FUNCTIONAL REVIEW AND EVALUATION -
BUILDINGS

B. C. REGION (June 22 - 25, 1982)

DECEMBER 1982

Indian and Northern
Affairs Canada

28. VENTING TO
BULKHEAD CONCEALING
SPRINKLER MAIN

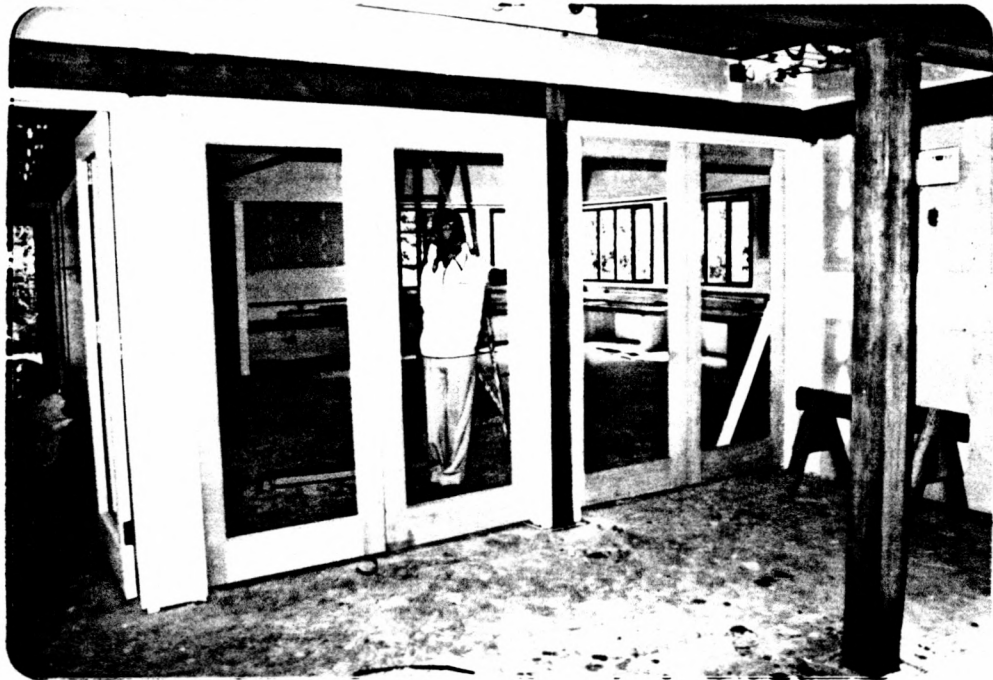
- a) Change order 14 for \$3,558 involved relocating the sprinkler main behind a special "ventilated" bulkhead at the library, outside the main wall of the building (see photo no. 28), together with a heating line to protect it. This was necessary due to a conflict between the intended route for the main and a beam. There is some danger of both lines freezing in case of a prolonged failure of the heating system, partly due to inadequate insulation of the bulkhead.
- b) Change order 18 for \$2,445 was for "trimming of roof trusses" due to settlement during erection. Although this work was covered in the specifications the contractor had not included it and was allowed an extra.

Finding (a) -- Change Order 14 was issued as a result of a sprinkler installation problem which became apparent during on-site measurement prior to fabrication. It was identified that the proposed route for the sprinkler line was in conflict with the sloping laminated beam at grid line G^o 12. Possible penetration of the beam was explored and found to be impractical due to required location and size of penetration. The re-routing of the line on the outer face of the beams was identified as being the only practical solution which would satisfy the sprinkler coverage requirements of the Dominion Fire Commission. In order to simplify piping runs, two 4,200 lengths of insulated bulkhead were constructed adjacent to grid lines G^o and 12.

32. STORE ROOM 120

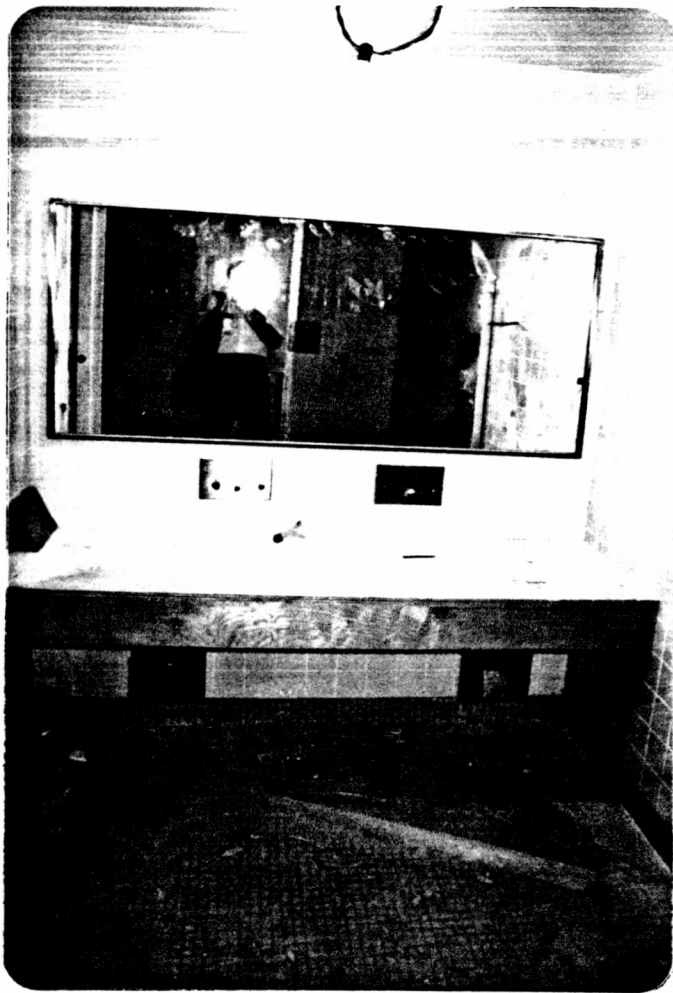
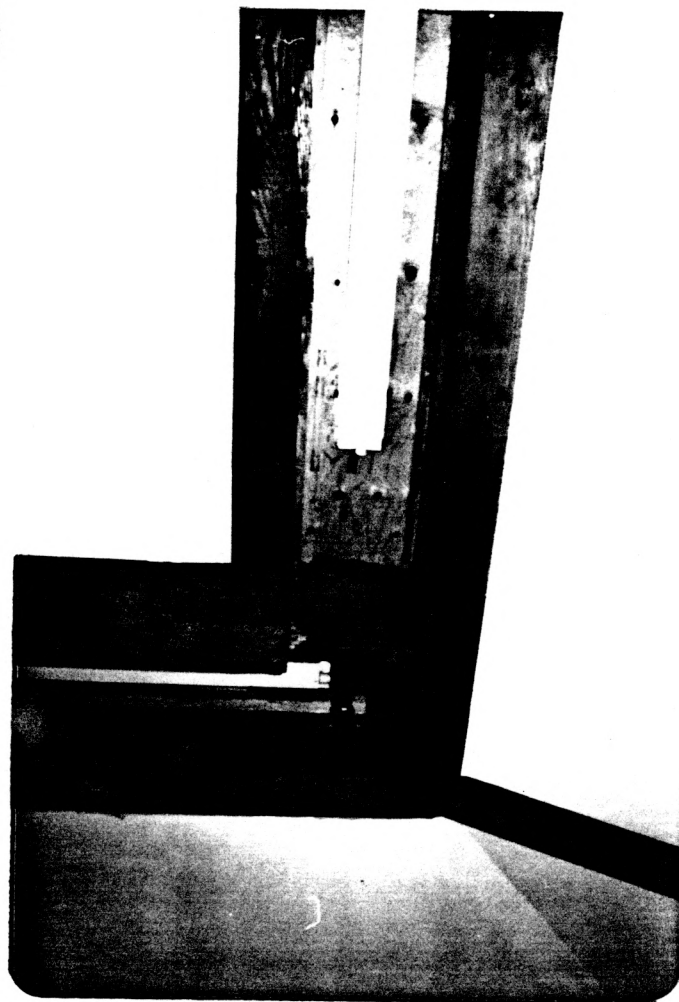
Counter in Chehalis Store Room 120 and vanities in washrooms have no splashbacks (see drawings A9, A10, D7/13 and photos Nos. 32 and 33). However detail 10 on drawing A10 calls for a splashback in the Store Room.

It is normal good practice for such counters to have splashbacks. Their absence will cause dirty and unsanitary conditions from water splashed over the tops during use, when they are washed, and from general use. Such omissions should be pointed out during document reviews. The Band should be advised and at least in the Store Room the contractor should be instructed to provide the splashback at no charge.
